SUBJECT: PRAIRIE ISLAND NUCLEAR GENERATING PLANT, UNITS 1 AND 2 - STAFF ASSESSMENT OF INFORMATION PROVIDED PURSUANT TO TITLE 10 OF THE *CODE OF FEDERAL REGULATIONS* PART 50, SECTION 50.54(f), SEISMIC HAZARD REEVALUATIONS FOR RECOMMENDATION 2.1 OF THE NEAR-TERM TASK FORCE (NTTF) REVIEW OF INSIGHTS FROM THE FUKUSHIMA DAI-ICHI ACCIDENT AND STAFF CLOSURE OF ACTIVITIES ASSOCIATED WITH NTTF RECOMMENDATION 2.1, "SEISMIC" (TAC NOS. MF3784 AND MF3785)

Enclosure:  
Staff Assessment of Seismic  
Hazard Evaluation and Screening Report

PRAIRIE ISLAND NUCLEAR GENERATING PLANT, UNITS 1 AND 2

Figure 3.3- 1 Plot of Staff's and Licensee's Base Case Shear-Wave Velocity Profiles for the PINGP Site

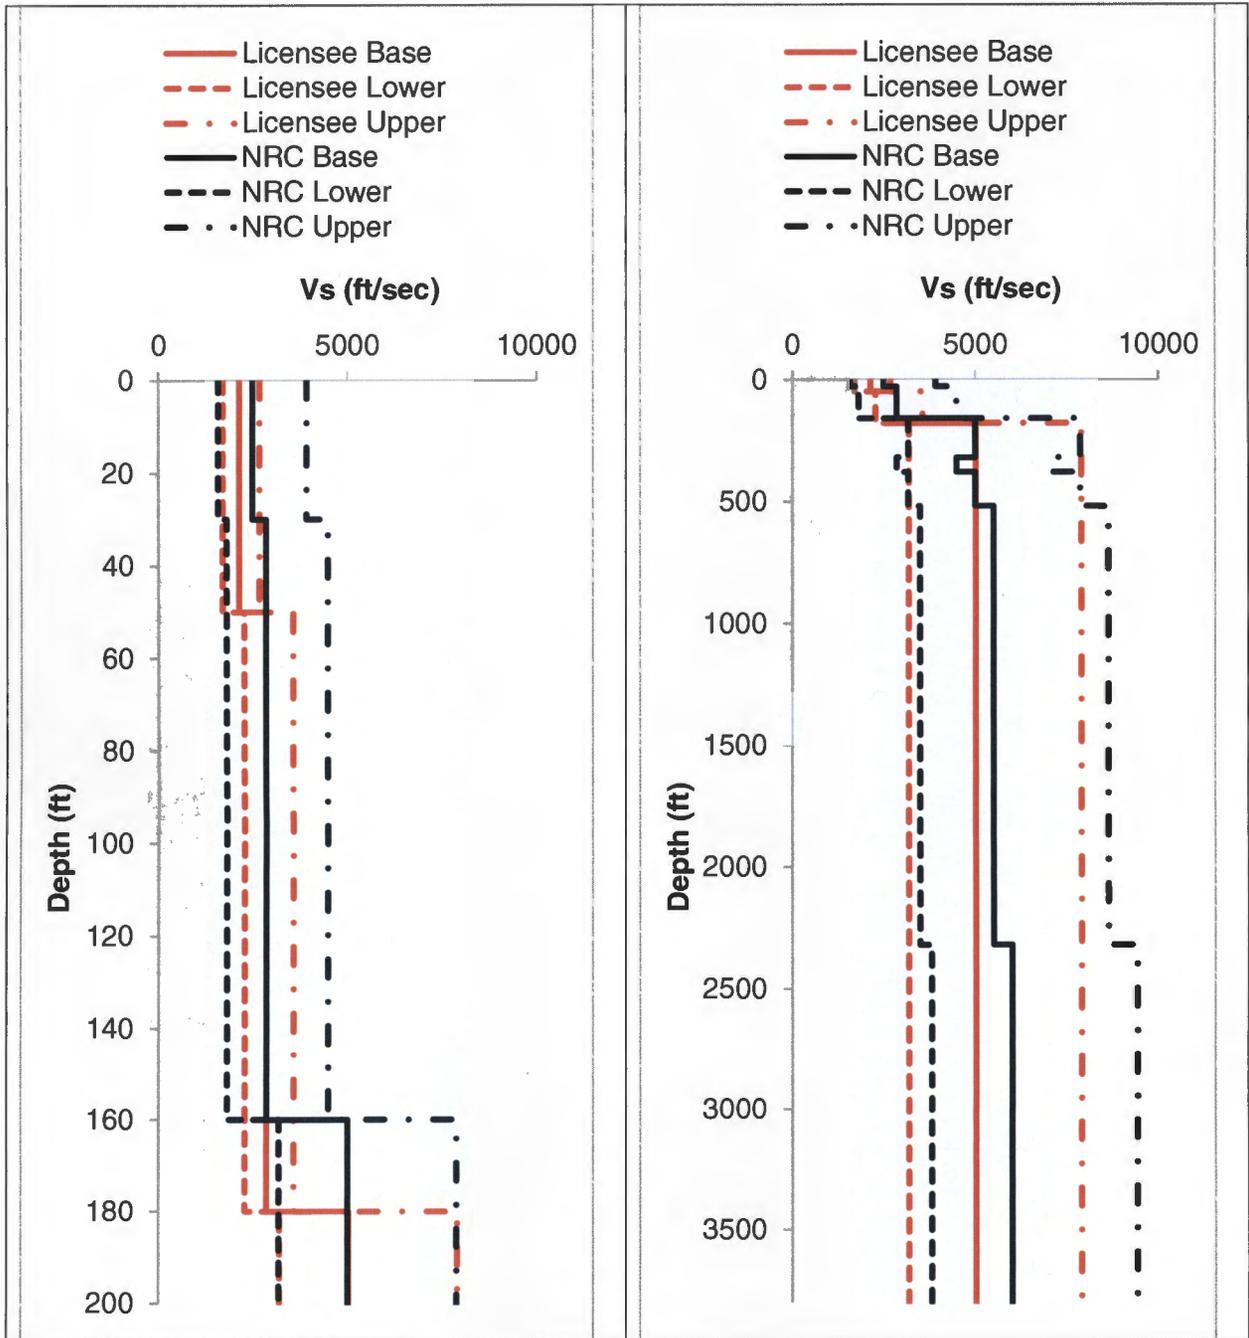
To characterize the subsurface geology, the licensee developed three site base case profiles. The middle, or best estimate, profile was developed using compressional-wave refraction surveys and assumed Poisson ratios. Upper and lower base case profiles were developed using a scale factor of 1.25 for the fill and glacial outwash and 1.57 for the firm sedimentary rock. The licensee noted that these scale factors reflect a log standard deviation of 0.20 and 0.35, consistent with guidance in the SPID. Figure 3.3-1 of this assessment shows the licensee's three shear-wave velocity base case profiles.

Site Parameter Study (GA-SPS, 1974). The NRC staff developed three separate profiles in order to capture the epistemic uncertainty in the modeled profiles. The staff's base case shear-wave velocity profiles are shown along with the licensee's base case profiles in Figure 3.3-1 of this assessment. The staff's shear wave velocity profiles agree well with those submitted by the licensee with only minor differences in the location of the interface between soil and sedimentary rock and the staff's selection of a broader range for the shear-wave velocity uncertainty in the upper 180 ft. [55 m] of the profile compared to the licensee's profile.

**Figure 3.3- 2 Plot Comparing the Staff's and the License's Median Amplification Functions and Uncertainties for two input loading levels for the PINGP Site**

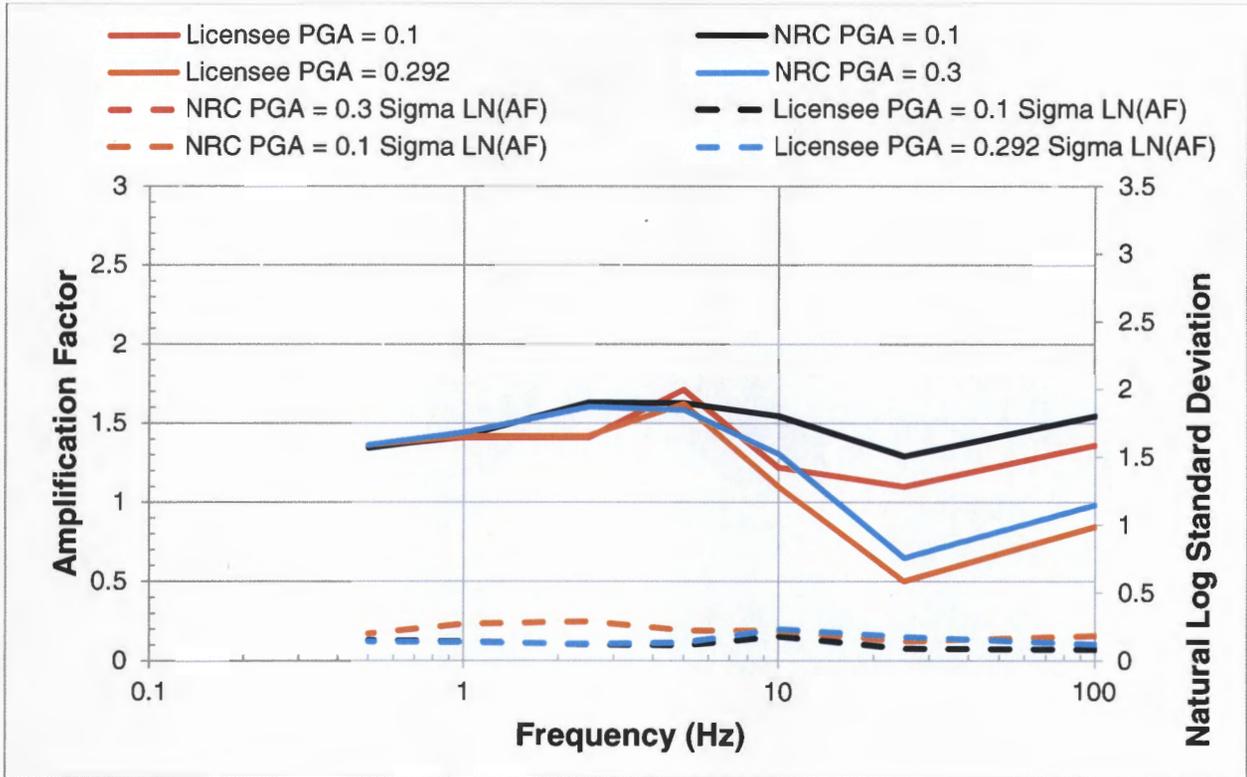
The median site amplification and associated uncertainty for 2 of the 11 loading levels are shown in Figure 3.3-2 of this assessment. Both the staff's and licensee's site amplifications are similar in shape with minor differences at peak amplification that are due to the differences in the velocity profiles and treatment of uncertainty for kappa between the staff's and licensee's analyses.

Figure 3.3-3 Plot Comparing the Staff's and the Licensee's Mean Control Point Hazard Curves at a Variety of Frequencies for the PINGP Site

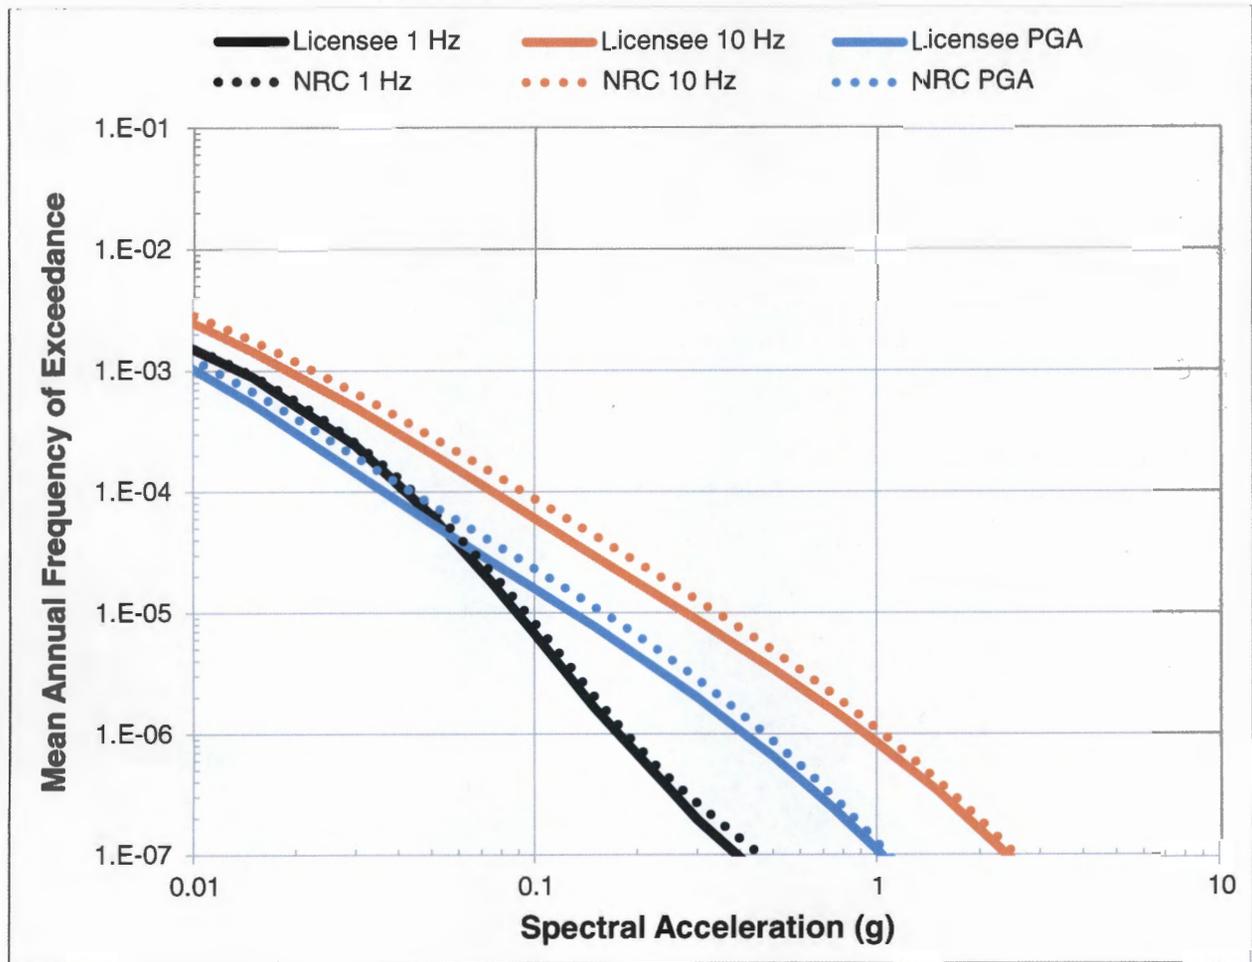
As shown in Figure 3-3-3 of this assessment, these differences in site response have only a moderate impact on the control point seismic hazard curves and the resulting GMRS, as discussed below. Appendix B of the SPID provides guidance for performing site response analyses, including capturing the uncertainty for sites with less subsurface data; however, the guidance is neither entirely prescriptive nor comprehensive. As such, various approaches in performing site response analyses, including the modeling of uncertainty, are acceptable for the 50.54(f) response.

**Figure 3.4-1 Comparison of the Staff's GMRS with Licensee's GMRS and the SSE for the PINGP site**

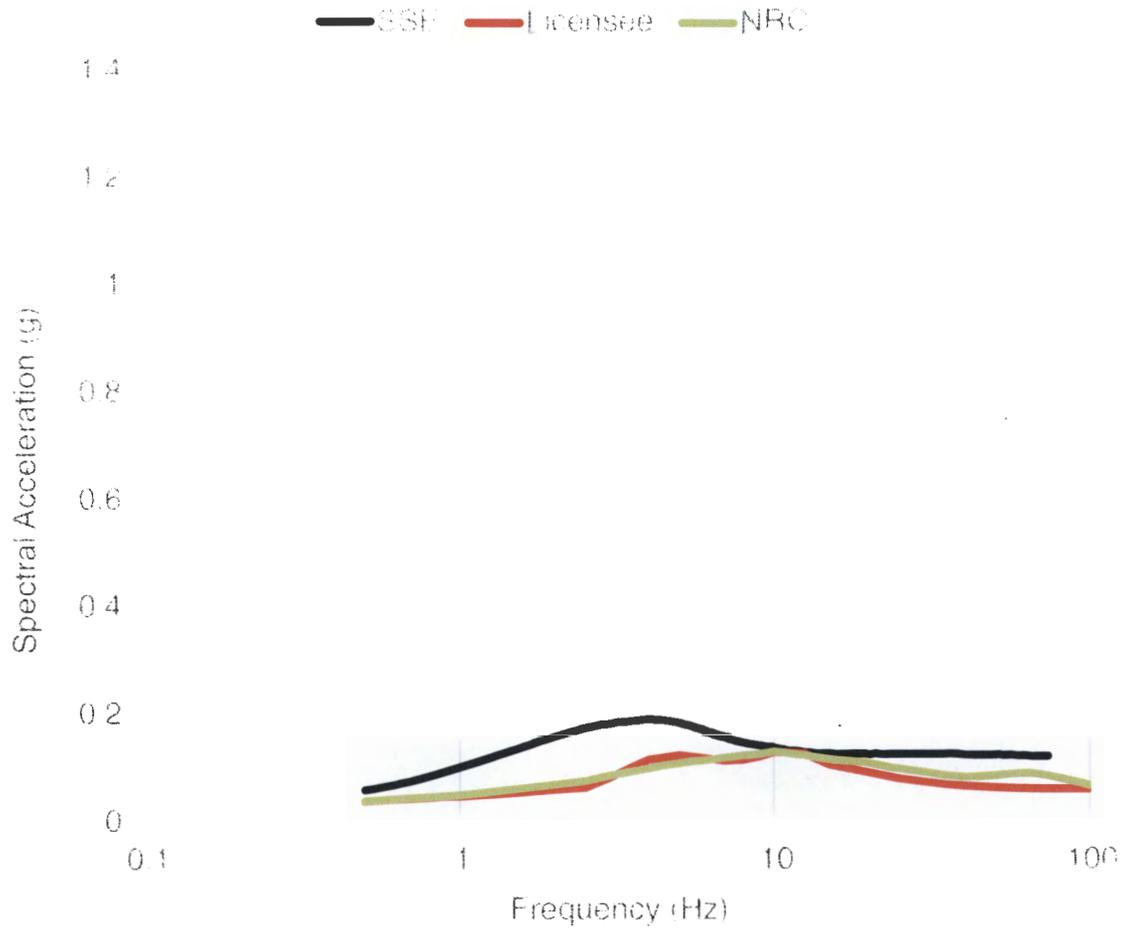
The NRC staff independently calculated the  $10^{-4}$  and  $10^{-5}$  UHRS using the results of its confirmatory PSHA and site response analyses, as described in Sections 3.2 and 3.3 of this staff assessment, respectively. Figure 3.4-1 of this assessment shows a comparison of the GMRS determined by the licensee to that determined by the NRC staff.

As shown in Figure 3.4-1, the licensee's and staff's GMRS shape are similar with minor differences for frequencies above 15 Hz. As described above in Section 3.3, the NRC staff concludes that these differences over this frequency range are primarily due to the differences in the site response analyses performed by the licensee and NRC staff. The NRC staff concludes that these differences are acceptable for this application because the licensee followed the guidance provided in the SPID with respect to both the PSHA and site response analysis for the PINGP site.
